Improved Technical Specifications

Dresden Station

Volume 4:
Section 3.3

ComEd

Table 3.3.1.1-1 (page 2 of 3)
Reactor Protection System Instrumentation

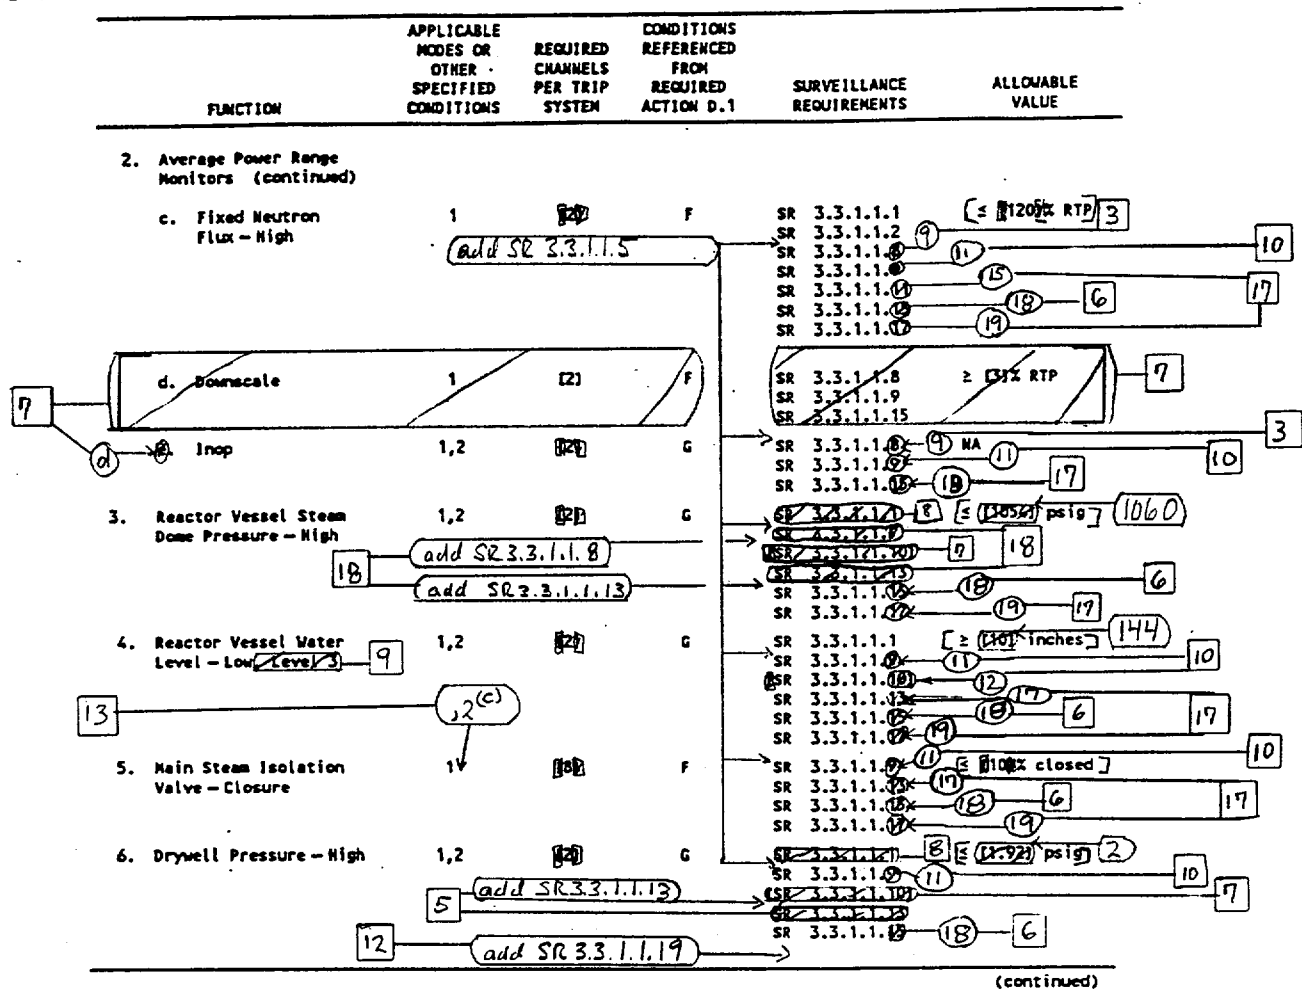
9. The proper Dresden 2 and 3 plant specific nomenclature/value/design requirements have been provided.
10. ITS Table 3.3.1.1-1 Function 10, Turbine Condenser Vacuum—Low, and associated footnote (c) have been added consistent with the current licensing basis for RPS Instrumentation. Subsequent Functions have been renumbered, as required. In addition, the Turbine Condenser Vacuum — Low (ITS Table 3.3.1.1-1 Function 10) Function is required to be calibrated every 31 days in accordance with the current setpoint methodology. Therefore, an SR has been added (ITS SR 3.3.1.1.10) to ensure the licensing basis is retained. Subsequent SRs have been renumbered, as required.

13. ITS Required Action F.2 for Function 5, Main Steam Isolation Valve - Closure, and Function 10, Turbine Condenser Vacuum - Low, has been added to require reducing reactor pressure to < 600 psig. The Applicability of ITS Table 3.3.1.1-1 Function 5 has also been revised to include MODE 2 and footnote (c), i.e., MODE 2 with reactor pressure ≥ 600 psig. These changes are consistent with the current licensing basis for RPS Instrumentation.

Table 3.3.3.1-1 (page 1 of 1)
Post Accident Monitoring Instrumentation

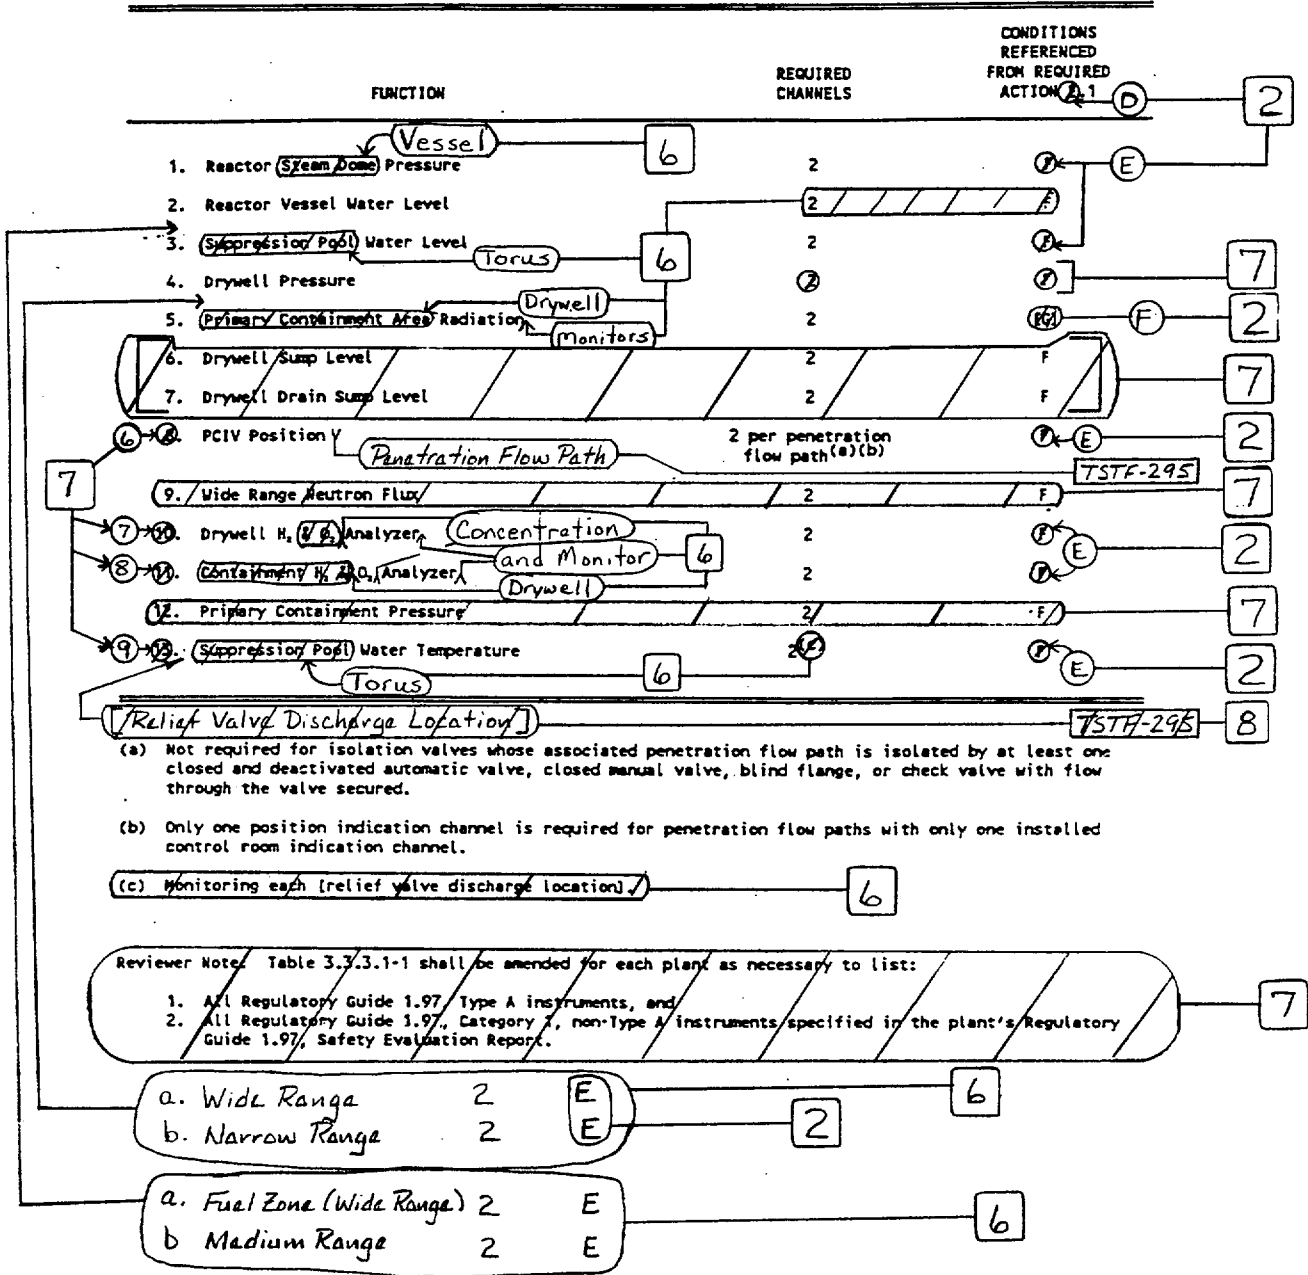
6. The proper Dresden 2 and 3 plant specific nomenclature/value/design requirements have been provided.
7. This Reviewer's Note has been deleted and the Table revised to include the appropriate instruments, consistent with the Note. The Note is not meant to be retained in the final version of the plant specific submittal. In addition, the Functions have been renumbered, where applicable, to reflect the additions and deletions.

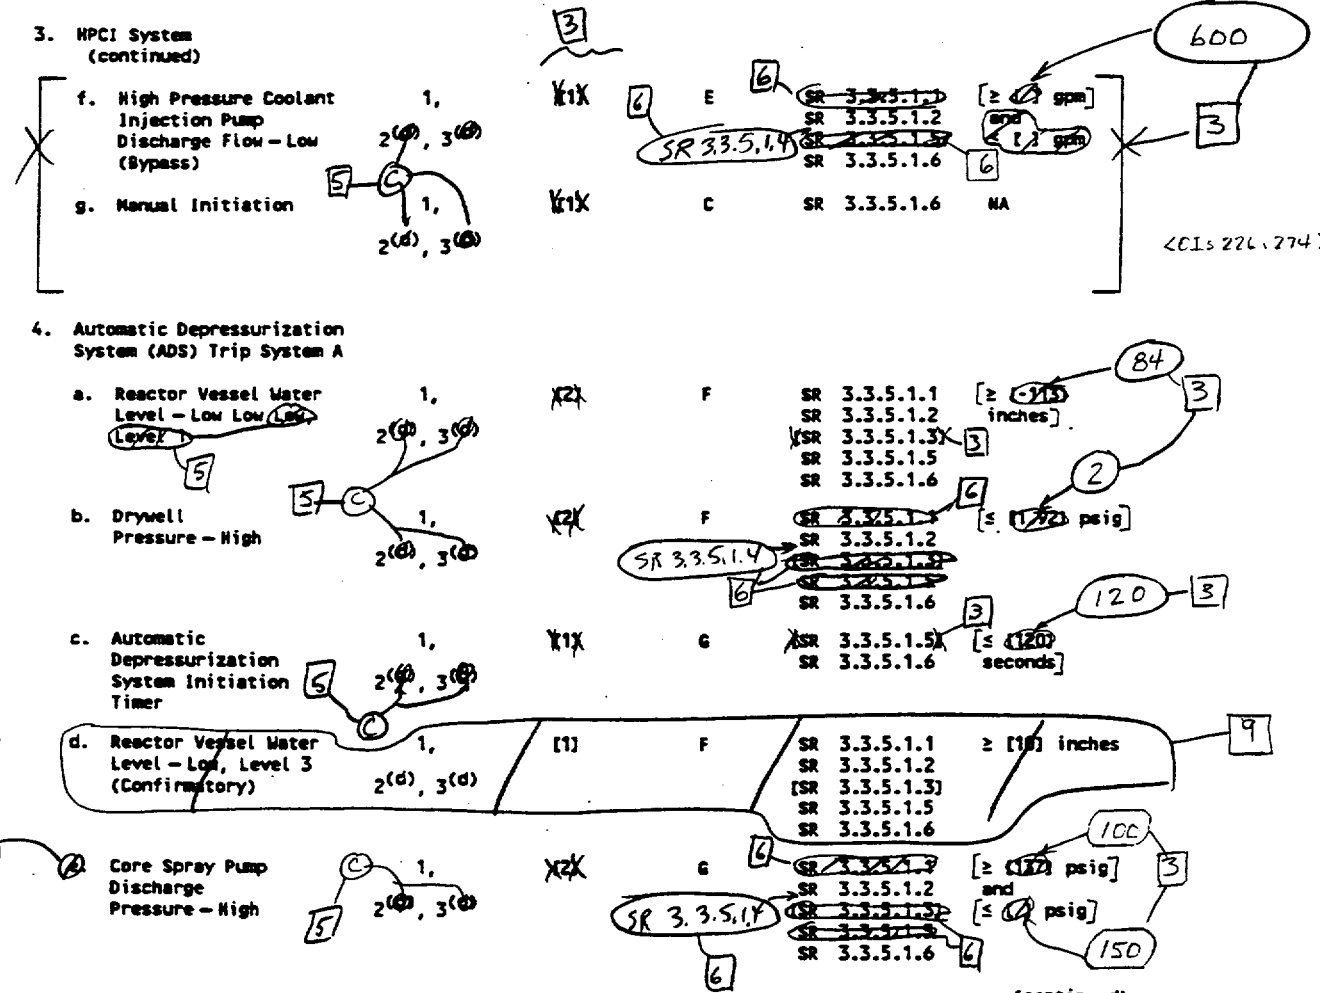
5. The proper Dresden 2 and 3 plant specific nomenclature/value/design requirements have been provided. Table 3.3.5.1-1 Footnotes have been renumbered, as required. Note 2 to Required Action B.1 and Note 2 to Required Action C.1 have been revised accordingly.

7. Footnote (a) to ITS Table 3.3.5.1-1 has been modified to only require the ECCS Instrumentation Functions to be Operable when the associated ECCS subsystem(s) are required to be Operable per LCO 3.5.2, "ECCS—Shutdown." Some of the Functions (ITS Table 3.3.5.1-1 Functions 1.a and 1.b) start the DGs in addition to the ECCS subsystems. This is shown in Footnote (b) to Table 3.3.5.1-1. As written, the ISTS implies that these Functions are required to be Operable when the DGs are required, even if the associated ECCS subsystems are not required. During shutdown Modes when the reactor cavity is flooded, the ECCS subsystems are not required to be Operable. Therefore, the ECCS start function of the DGs serve no safety significant support function. As such, these instrument Functions are not required and have been deleted from the ITS when only the DGs are required to be Operable. This change is also consistent with current licensing basis (CTS Table 3.3.3-1 Footnote * only requires these Functions when the system is required to be Operable per CTS 3.5.B, the ECCS—Shutdown Specification). The DGs are still required to be started on a loss of power signal, as required in ITS 3.3.8.1.
